egusphere-2024-863 response to Anonymous Referee #2

In this study, the authors present a framework to sequentially couple the ice dynamical part of the Open Global Glacier Model (OGGM) with the full energy balance model for snow and ice from the Joint-UK Land Environment Simulator (JULES). The authors apply this sequential (offline) coupling to 500 glaciers in the tropical Andes and make projections of glacier mass loss until 2100 for different RCP scenarios. They conclude that under RCP4.5 17% of the ice mass will still remain by 2100 which is more than what other glacier modelling studies have predicted e.g., compared to 2% as predicted by GloGEM (Huss and Hock 2015) and Marzeion et al. 2012.

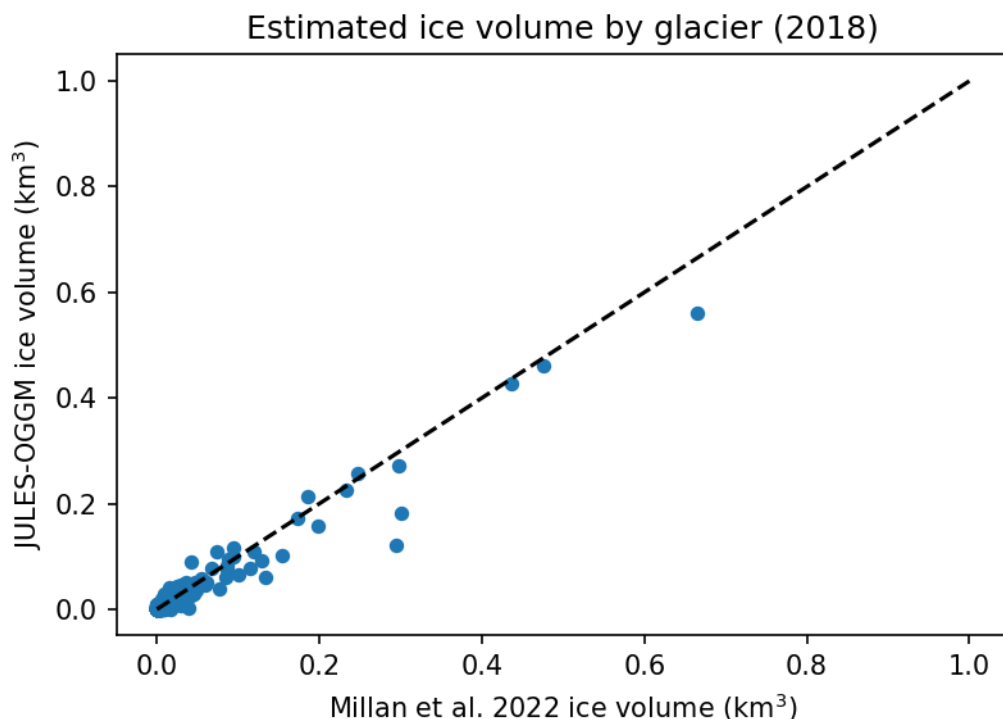
- The simulated glacier geometry that results from the interaction between mass balance and ice flow processes should be compared to ice thickness or volume observations. This is important as the initial glacier state can have a large impact on the simulated glacier evolution (Zekollari, et al. 2022). Authors do not validate the initial ice thickness distribution obtained with their JULES-OGGM framework before doing future simulations. They only evaluate the model by comparing simulated SMB to geodetic and in situ SMB observations.

There might not be in situ glacier thickness measurements for these glaciers, however, the authors could check how their simulated initial ice volumes or ice thickness distributions

compare to those from Millan et al (2022) at least for glacier wide volume estimates. Millan et al (2022) is a satellite derived ice thickness product and uses, like OGGM, mass conservation and the SIA, these are not in situ ice thickness observations but if compared to model initial model simulations could provide an idea of the calibration error for the ice dynamic part of the workflow. In other words, errors derived by not calibrating ice dynamical parameters in OGGM or by not updating glacier geometry changes in JULES. By looking at Millan et al (2022) Figure 3b seems to be data available for C Vilcanota glaciers. I encourage the authors to make such a comparison as this could strength the findings of the manuscript.

We really like the idea of having an independent source of validation for the glacier geometry. It's worth noting that, for the initial ice mass at least (year 2000), we show that, cumulated over the VUB, our estimate sits between estimates used for GloGEM and MAR2012 as part of the GlacierMIP experiments (Figure C1 c&d). **We don't make this point in this text and so, will do so in the revised manuscript.** Having looked at the Millan et al. (2022) study, this looks like a promising basis to do a glacier-specific validation. Having read the manuscript in detail, we would highlight several important considerations of using these data:

- 1) Their ice thickness estimates would not permit the validation of the initial ice geometry specifically as suggested by the referee. This is because their calculations are derived from maps of ice velocity are estimated from the years 2017-2018. Our simulations are initialised for the year 2000.
- 2) They note that the “temporal mismatch” between the ice velocity product, digital elevation model and glacier outlines are important sources of uncertainty which can't easily be quantified. An important component of this is the glacier outlines. They use the same outlines as our initial glacier area (for the year 1998).
- 3) Errors in ice thickness for thicknesses below 100 m (this accounts for 95% of the glacierised area in the VUB according to this study) are assumed to be >50%.

While there are undoubtedly limitations of using these data, they are the current state-of-the-art and, therefore warrant being used in our analysis. We were keen to conduct this analysis, even before submitting our revisions, and so have done so considering this suggestion. In the figure below, the Millan et al. (2022) ice volume data are plotted against the JULES-OGGM simulation for 2018 for all glaciers. As we note above in limitation 1, we can't use these to validate the initial geometry specifically, but this comparison does implicitly validate this as well as the dynamic behaviour of the model over the 2000-2018 simulation period. Most simulations sit close to the 1:1 relationship (black dashed line). The total JULES-OGGM ice volume for glaciers where Millan data are available (not all glaciers in the VUB) is 7.19 km³ whereas Millan et al. (2022) estimate it as 8.16 km³. The lower estimated volume is perhaps not surprising, especially due to much older glacier outlines used to estimate these. **We will include this analysis and discussion of the limitations of the data and modelling approach in the discussion.**
